## Heritage, Setting and Visual Impact

Little Gains Farm (LGF) is a non-designated heritage asset (HER MKE83194) which adjoins the DCO order limits.

*Figure 1 View form Little Gains Farm northwards towards the Aldington Ridge (and across the proposed development)*

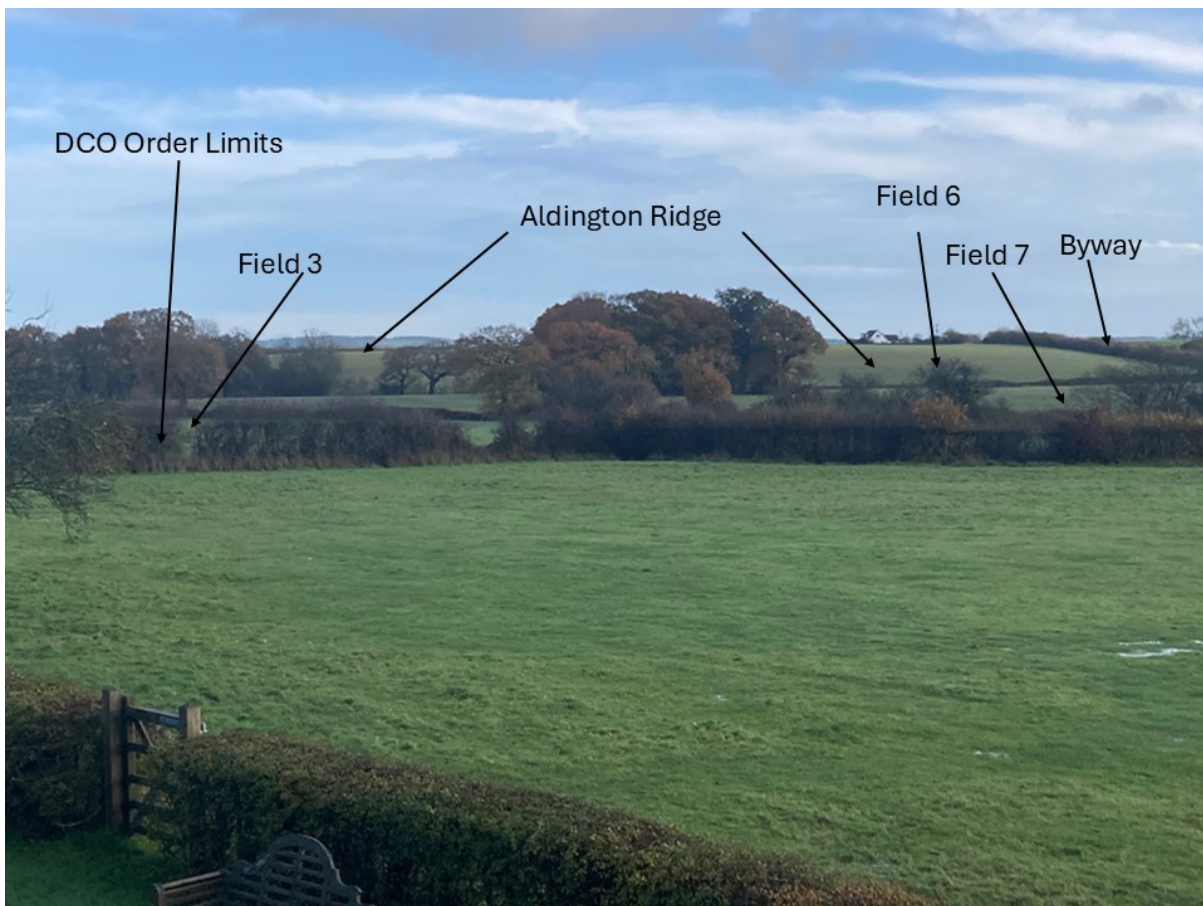
In reality the setting of Little Gains Farm is defined by its location on the southern flanks of the Aldington Ridge, which can be seen clearly from the house and its surroundings (Figure 1).

As demonstrated by photos in Figures 1 and 2 there are clear views of the Aldington Ridge from Little Gains Farmhouse and consequently the proposed development.

These views would be replaced by solar panels, batteries, water towers and the associated glint and glare.

Figure 3 Proposed Screening along the southern boundaries of Fields 3 and 7 and proposed new pond and existing ponds.

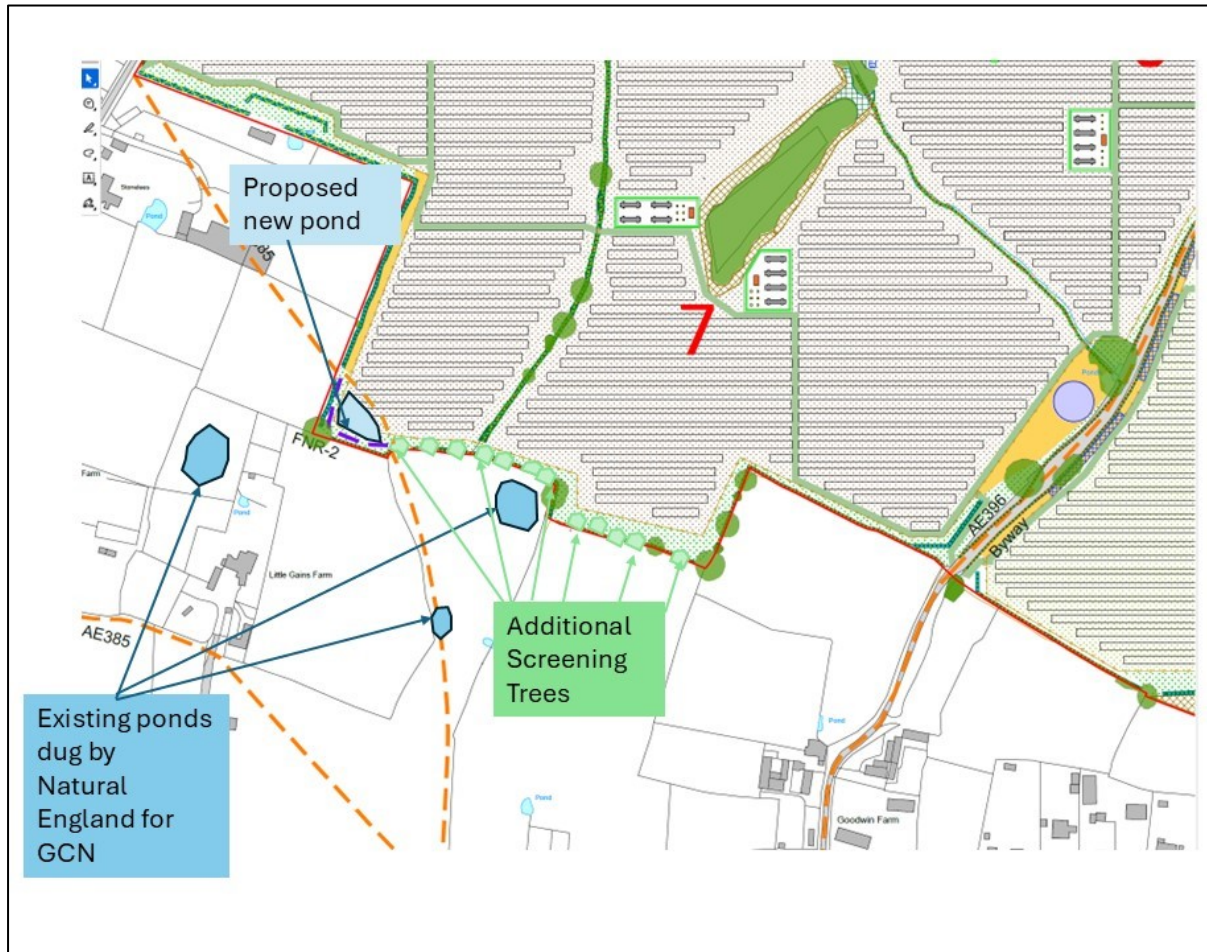
The proposed diversion of this footpath provides very little extra land for solar panels, making more sense to leave the footpath as existing and dig a new pond in this wet corner. This would help promote the Great Crested Newt, which is protected under British and European Law.

**Natural England** have dug three ponds in the land adjoining the DCO Order Limits, in this area (Figure 3), which are not shown on any of the Applicant's maps. These large ponds have increased the population of Great Crested Newts in the area

screening in the form of tree planting is required along the southern boundary of Fields 3 and 7 (Figure 3). Panels should be removed from the area adjacent to this boundary to accommodate tree planting.
